Exhibit B-29

Re: Planning Commission Recommendation for Toll PA XVIII, L.P.
Conditional Use Application II for Flexible Development of Crebilly Farm

EXHIBIT A

Re: Conditional Use – The Robinson Tract
Westtown Township - CU-09-19-16071

Figure 2: Site Plan Detail, Sheet 12, Conditional Use Application, The Robinson Tract

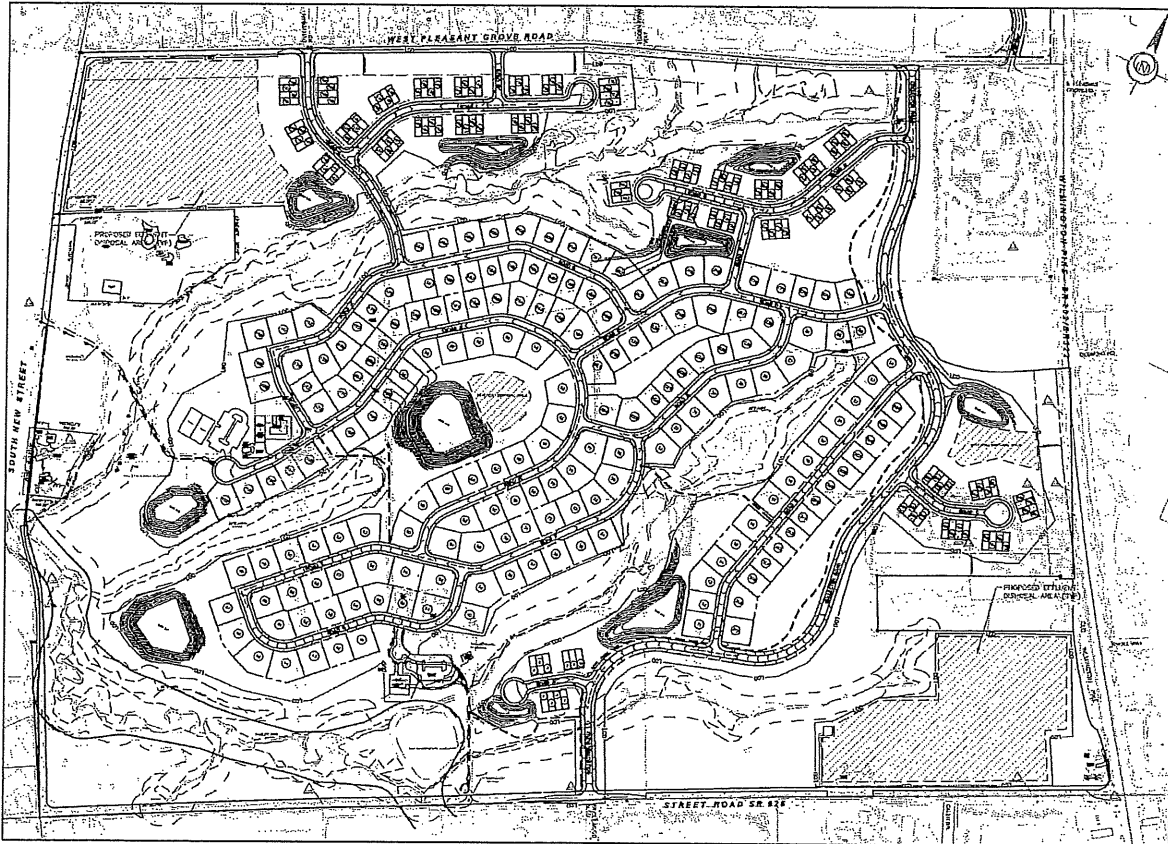
While single family detached and townhouse development is an appropriate use in a **Suburban Landscape** designation, the proposed residential development on the western portion of the site is not consistent with the goals and objectives of the **Rural Landscape** designation nor is it consistent with the historic resource and context preservation policies of *Landscapes3*. In order for the proposed development of the Robinson Tract to be generally consistent with *Landscapes3*, the applicant and Township should consider the development of a revised site plan in which the proposed development activity is located, to the greatest extent possible, on the eastern portion of the site (this issue is further discussed in comment #5).

24. While Sheet 12-Overall Lot Layout provides a brief list of the tract area, proposed density and proposed impervious coverage of the development, it does not provide a zoning compliance table. This should be clarified by the applicant.

Figure 3: Brandywine Battlefield Swath, Approximate troop movements and battlefield skirmishes

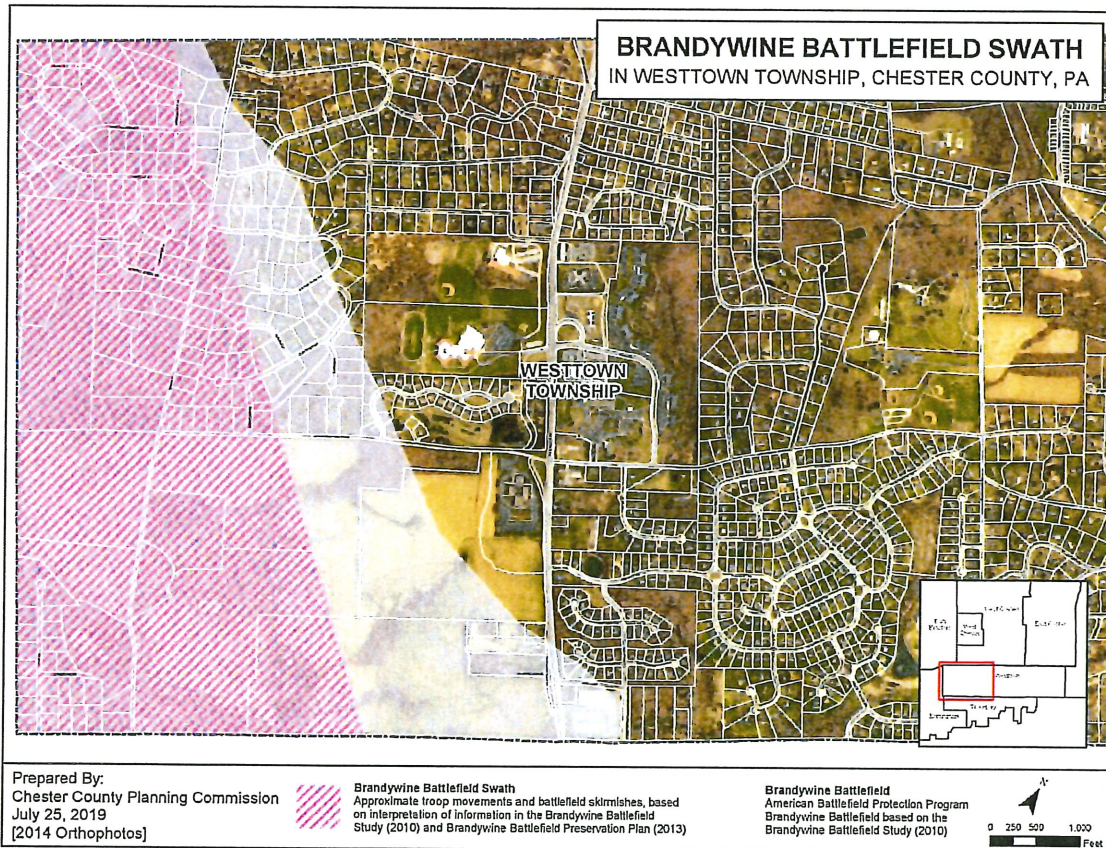
- 22) Prior to issuance of grading permits, Applicant shall cause to be conducted an archeological survey including ground penetrating radar survey of any areas proposed to be disturbed within the Brandywine Battlefield Swath which is depicted on the CCPC review letter dated October 18, 2019, Figure 3. Applicant shall share the

Figure 4: Chester County Planning Commission's conceptual illustration of development on the Robinson Tract (December 7, 2016)

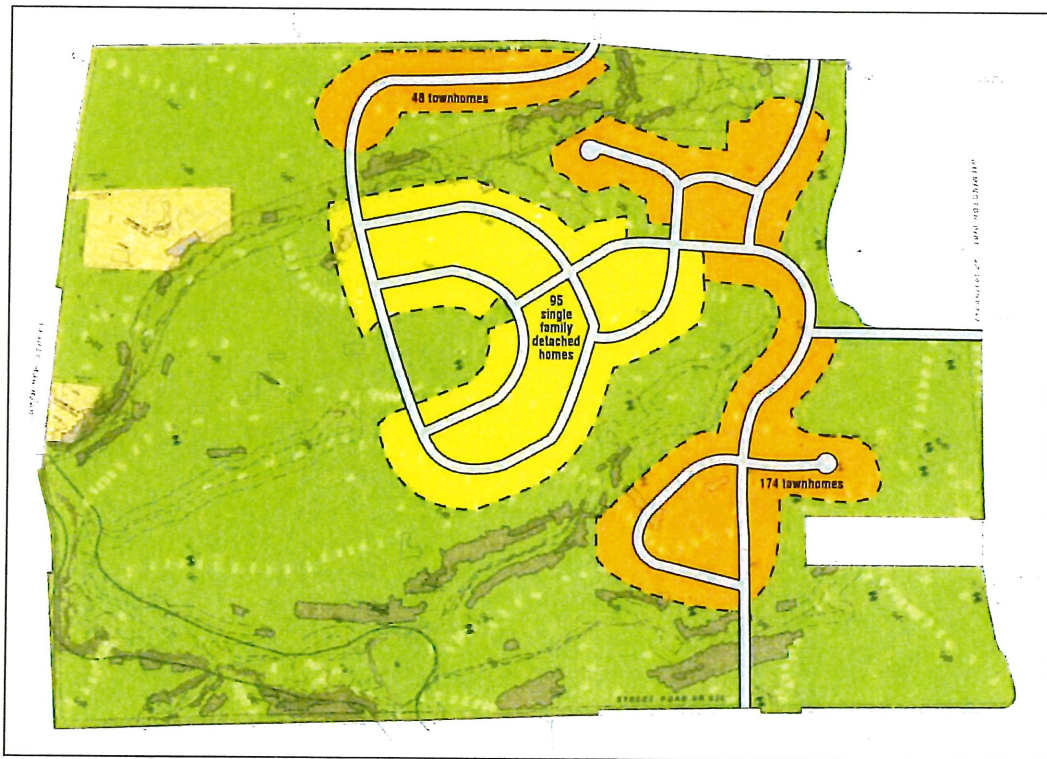
Figure 4, which was also provided in our previous review letter, provides a conceptual illustration of how development activity on the Robinson Tract can be located outside of the majority of the Rural Landscape and Brandywine Battlefield area. The County Planning Commission would be happy to work with the applicant and the Township on alternative sketch plans of the site that have a higher proportion of townhouses, along with more open space provided on the portion of the tract located in the Rural Landscape.

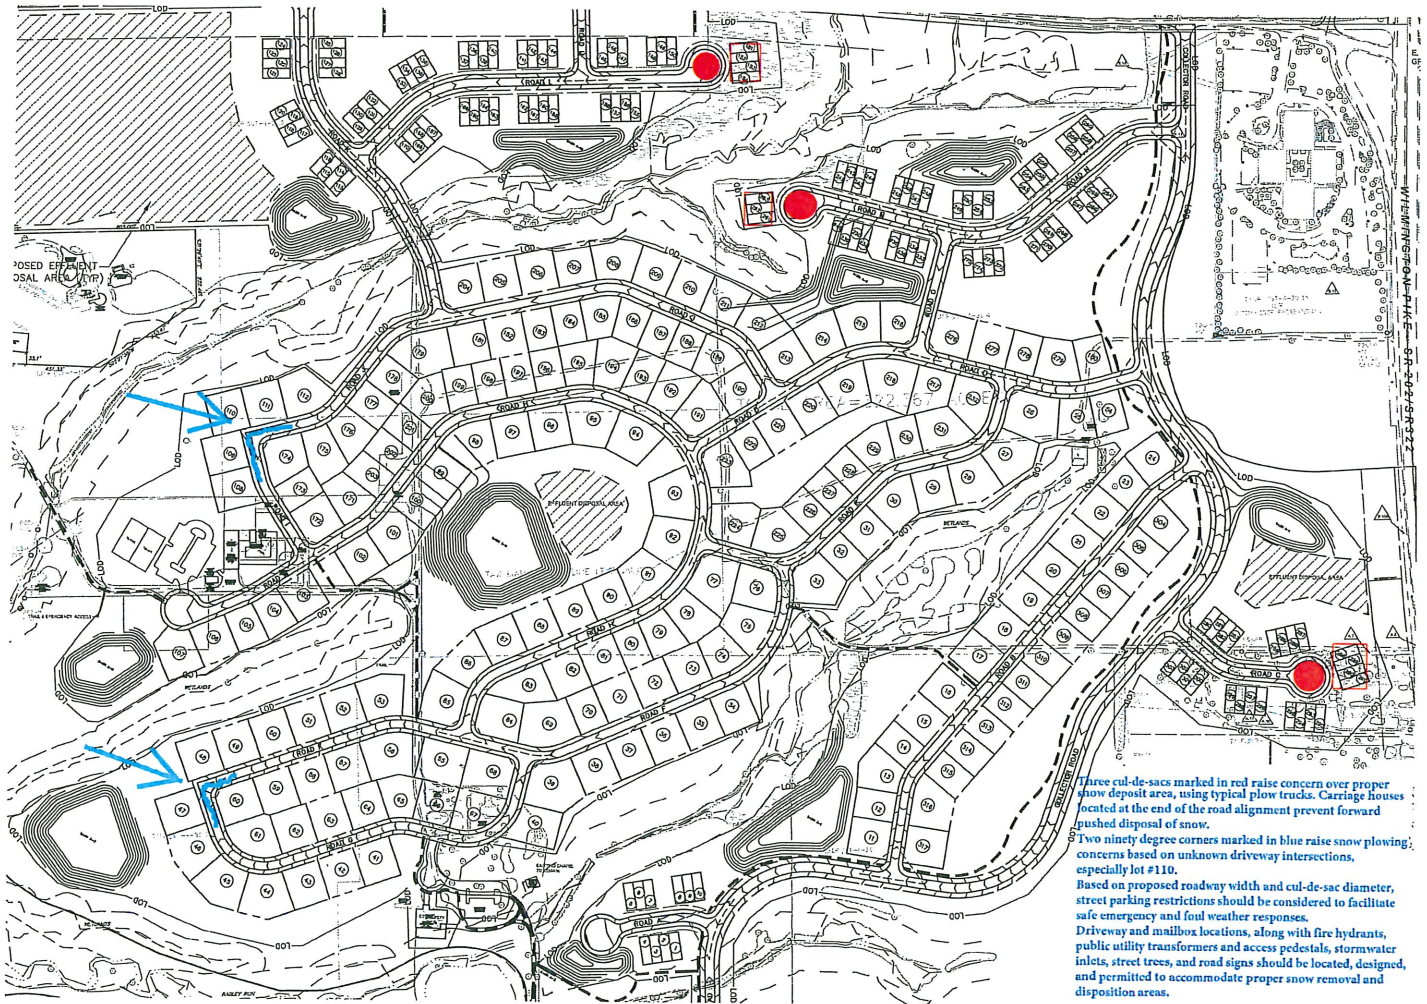
Three cul-de-sacs marked in red raise concern over proper snow deposit area, using typical plow trucks. Carriage houses located at the end of the road alignment prevent forward pushed disposal of snow.

Two ninety degree corners marked in blue raise snow plowing concerns based on unknown driveway intersections, especially lot #110.

Based on proposed roadway width and cul-de-sac diameter, street parking restrictions should be considered to facilitate safe emergency and foul weather responses. Driveway and mailbox locations, along with fire hydrants, public utility transformers and access pedestals, stormwater inlets, street trees, and road signs should be located, designed, and permitted to accommodate proper snow removal and disposition areas.

- 49) Applicant shall revise the Plan to relocate the proposed carriage homes at the end of the cul-de-sacs which are highlighted in red on the attached map which was prepared by the Township's Public Works Director. The Plan shall provide open areas off of the cartway of the cul-de-sacs to allow for the deposit of snow that is shoveled from the road.

- 50) Applicant shall revise the Plan to redesign the 90° bends in Road J and Road F which are highlighted in blue on the attached plan to eliminate difficult maneuvers by snowplow vehicles.
